DRAWING NO. D3016	TITLE SEAT FRAME ASSEMBLY	REV. A	DART AEROSPACE LTD ENGINEERING ORDER	D.E.O. NO. D3016-A-1	SHEET NO. SHEET 1 OF 1	SCALE NTS
DRAWN 1	CHECKED UP	MFG. APPR. BE	APPROVED MP	DE APPR. TH		
DATE 10.01.29	DATE 10.01.29	DATE 10.01.29	DATE 10.01.29	DATE 10.01.29

PURPOSE:

TO REVISE D3016-11 SADDLE'S HOLE SIZES

D3016-11 SADDLE

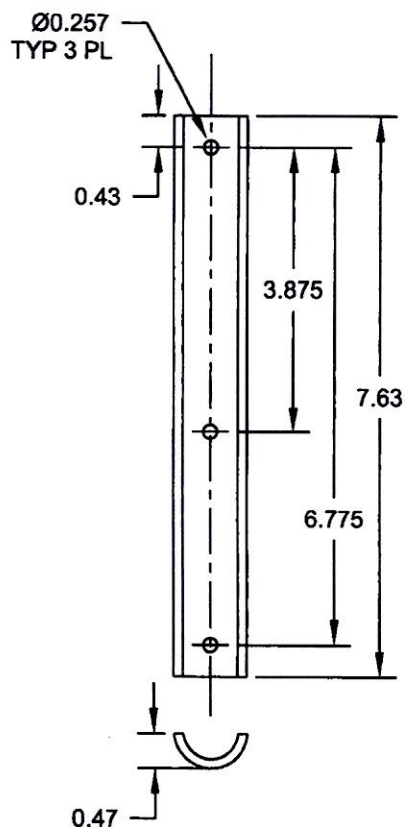
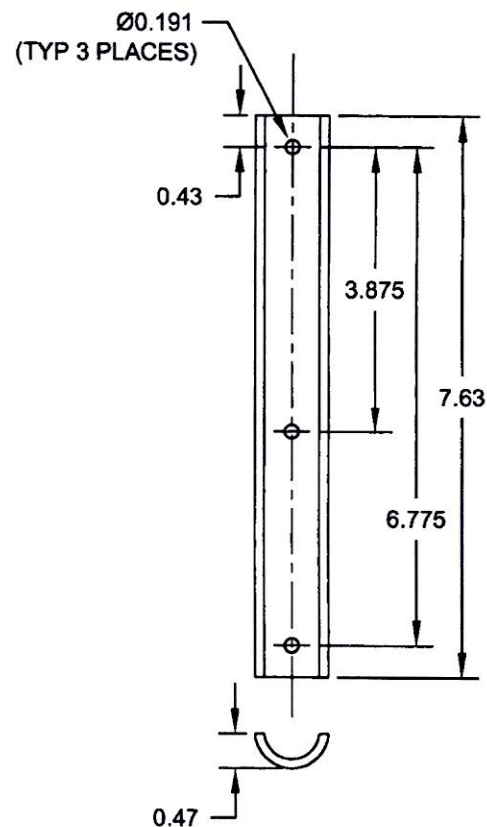
DETAIL D3016-11 SADDLE (SHEET 3): Ø0.257 TYP 3 PL WAS Ø0.191 (TYP 3 PLACES) AS SHOWN:
